# **Application for Design Review - Staff Report of Findings**

**Property Address:** The Chancery Building, 1023 W Riverside Avenue

**Type of Work:** Demolition of Contributing Structure in National Register Historic District;

Application for approval of new construction replacement structure

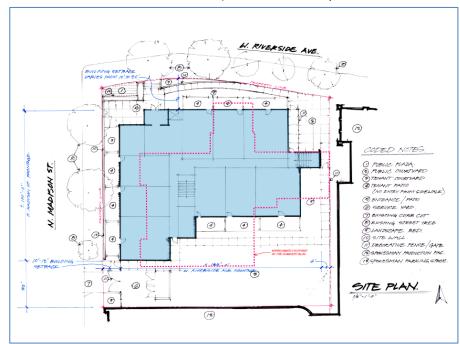
**Comment:** The proposed building's size, scale and form are consistent with the overall character of the district. The applicant did use some architectural cues from the facing block in terms of the building's composition and modeling. The buildings directly across from the Chancery have repeated patterns of column and window openings, this building does use a repeated pattern in the window openings. The setback and darkened 4th floor of the proposed building does take subtle cues from the Masonic Temple across the street, albeit with a contemporary interpretation.
